Detailed Site Plan

DSP-06001-03

The Commons at Addison Road Metro

STAFF REPORT

Figure 3: Proposed Freestanding Sign

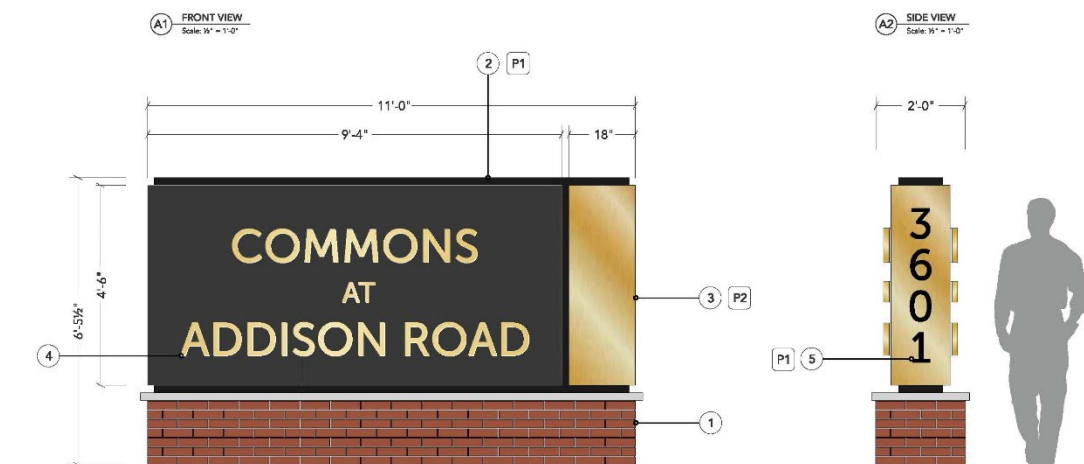
One six-foot-tall, double-faced, freestanding sign is proposed along Addison Road, near the entrance to the site. The sign is constructed of aluminum and mounted on a brick veneer base. The sign includes back-lit, gold leaf lettering on a black background. The 11-foot-wide sign includes landscaping at its base for seasonal interest and has been found acceptable, with the exception of the illumination, which is not allowed by the D-D-O Zone; however, an amendment to allow the sign's illumination is recommended for approval.
